BRIGGS RANCH

Preliminary Overall Area Development Plan

Re: Briggs Ranch (West) POADP # 710

The City Staff Development Review Committee has reviewed Briggs Ranch (West) Preliminary Overall Area Development Plan # 710. Please find enclosed a signed copy for your files. Your plan was accepted, however please note the following:

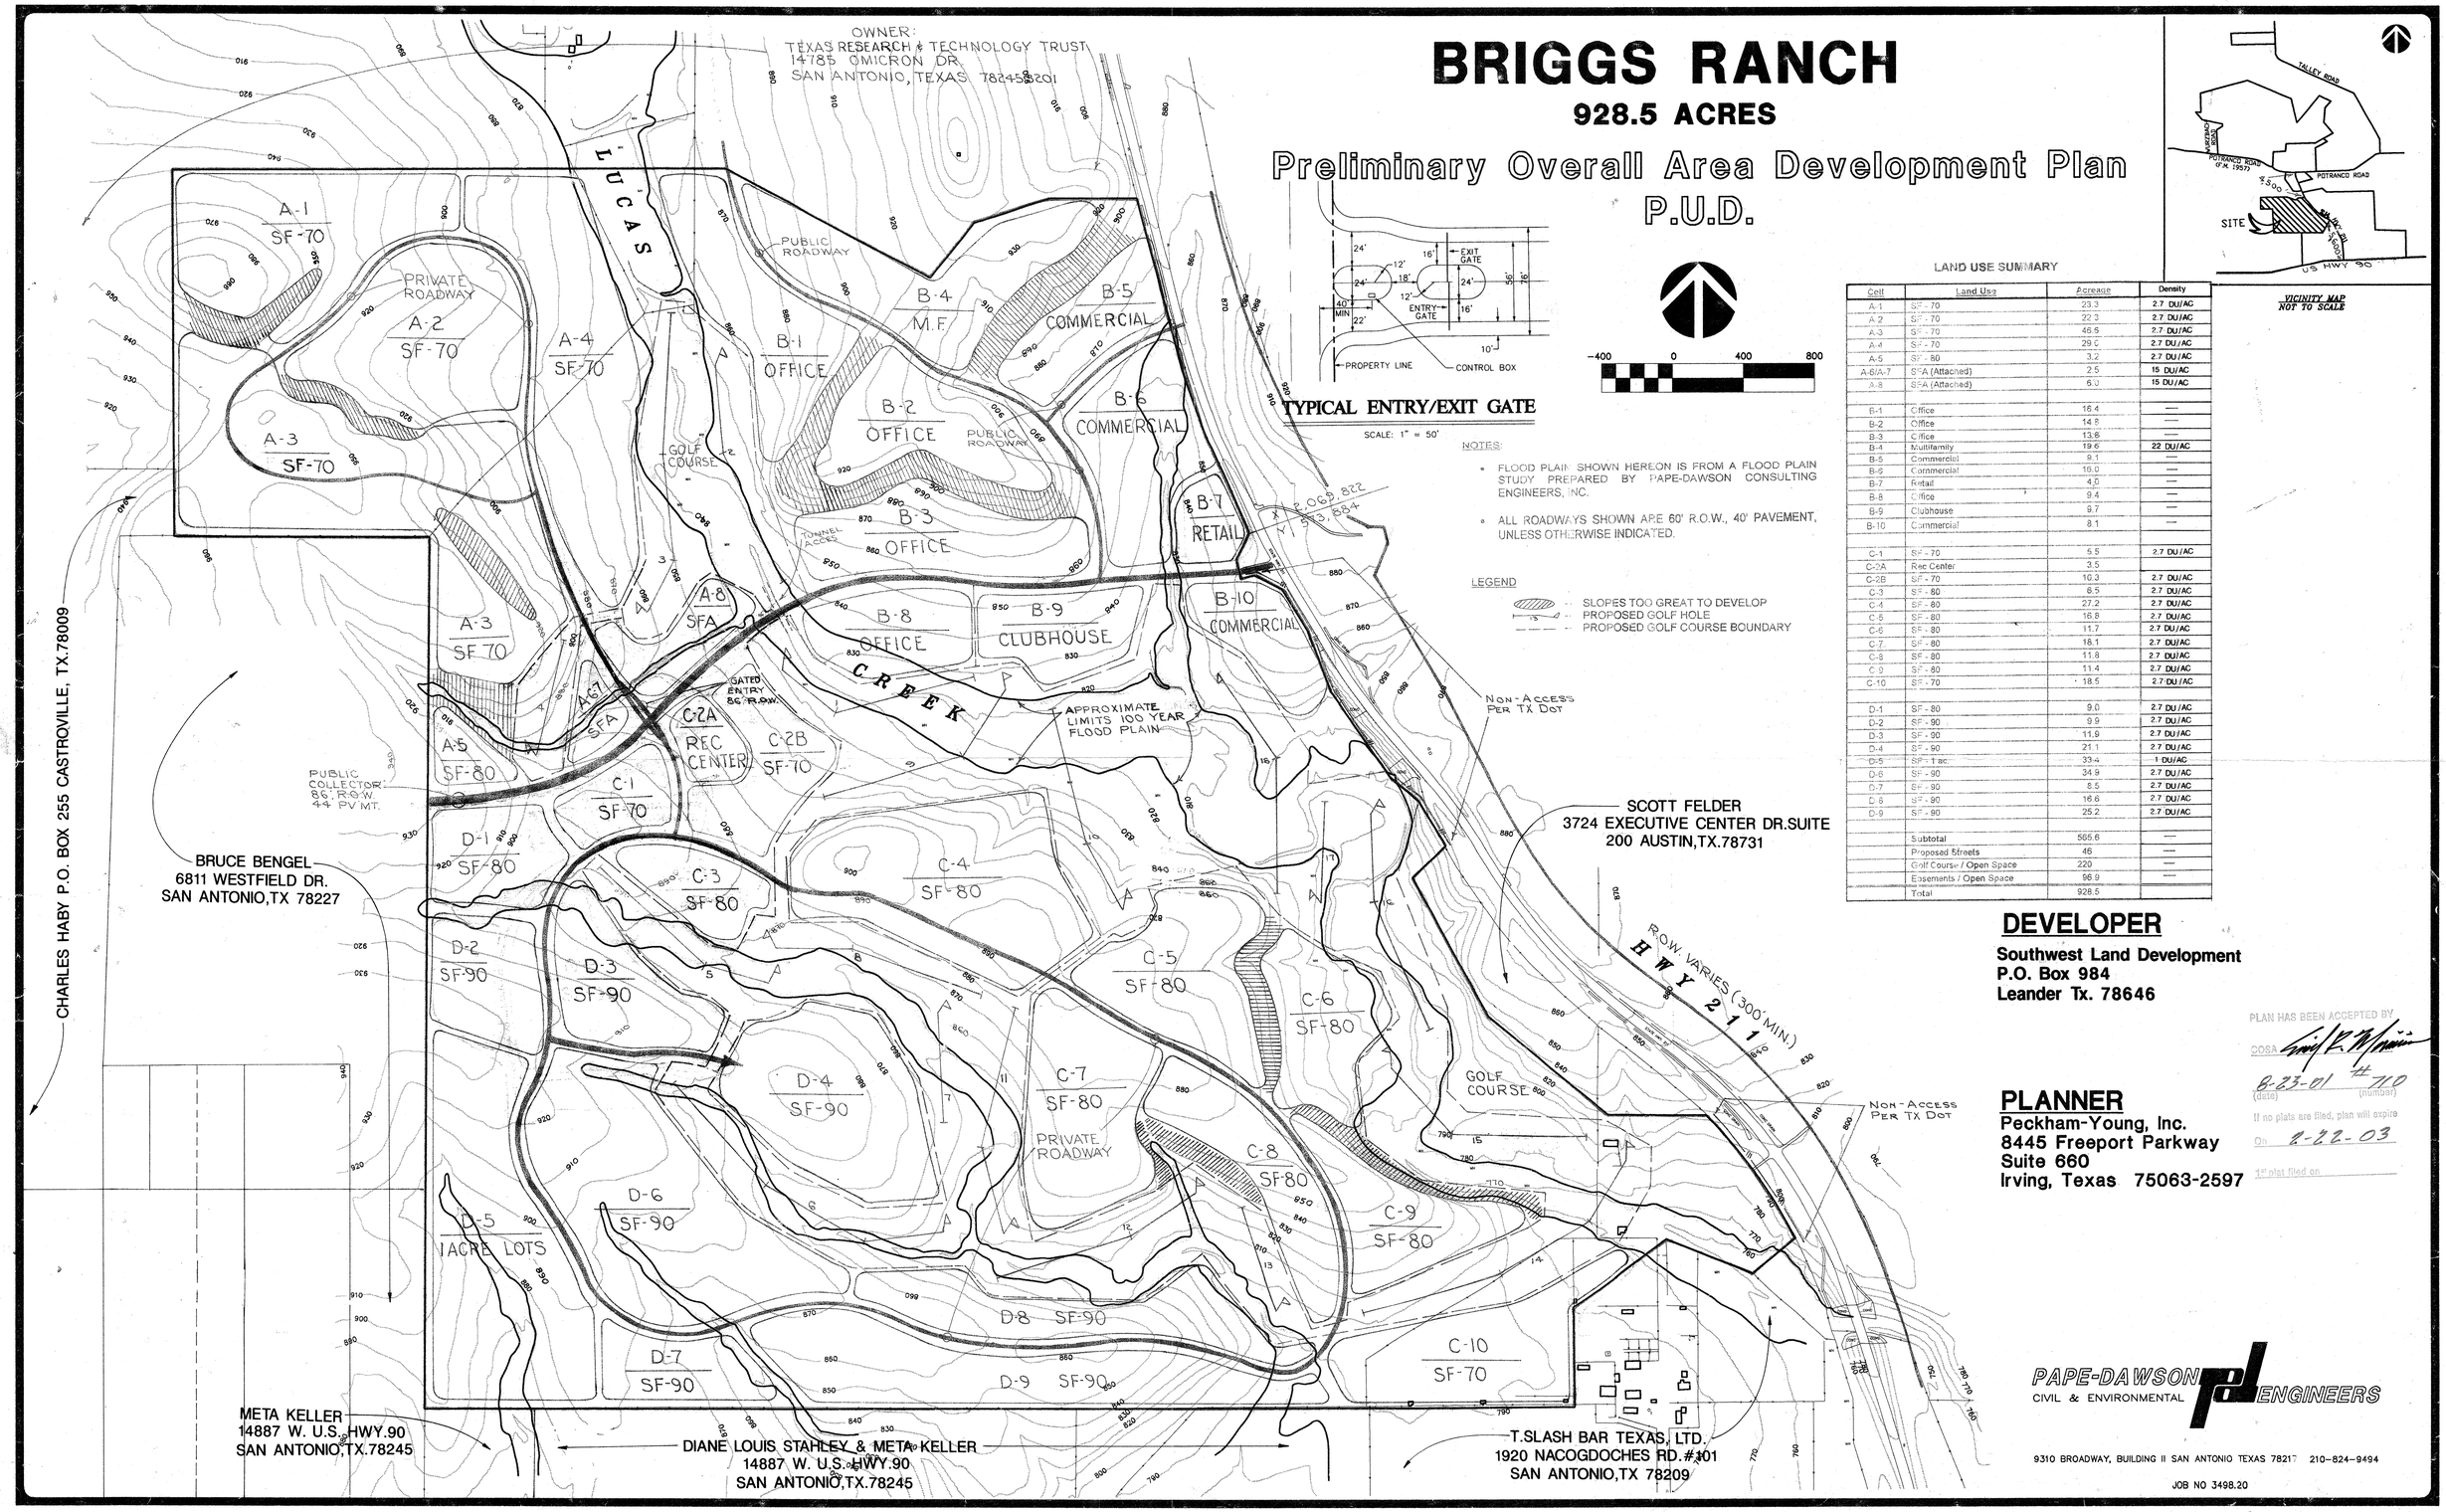
- In consideration of public safety and convenience, excessive grades by reason of topography should be avoided in street layouts and arrangements.

- Access and R.O.W. issues along state facilities will need to be resolved with the Texas Department of Transportation (TXDOT). For information about these requirements you can contact TXDOT at 615-5814.

- This development will need to comply with tree preservation ordinance #85262. For information about these requirements you can contact Building Inspections at 207-7102.

- It will be expected that you will plat all of the property depicted in your POADP, to include: floodplains, drainage areas and open space.

Comments:
Coordinate tree preservation
preserve 100 yr flood plain in a natural state

Comments: Pending on the following comments.
- Flood study to determine BFE
- Water Purveyor / Sewer System
- Street stub-outs

Comments: HWY 211 IS ON THE MTP AND TXDOT SYSTEM REQUIRING A MIN. OF 110' ROW AND TXDOT RELEASE. PROPOSE MARBACH THOROUGHFARE IS ON THE MTP REQUIRING A MIN. OF 86' ROW.

P.O.A.D.P. Reviewed for:	Comments
Noise Mitigation	For residential development directly adjacent to State ROW, the developer shall be responsible for adequate set-back and/or sound abatement.
R.O.W. Requirements	None anticipated at this time.
Access Limits/Restrictions	Access to SH 211 will be as directed by "Regulations For Access Driveways to State Highways". See additional comments below.
WPAP Requirements	None.
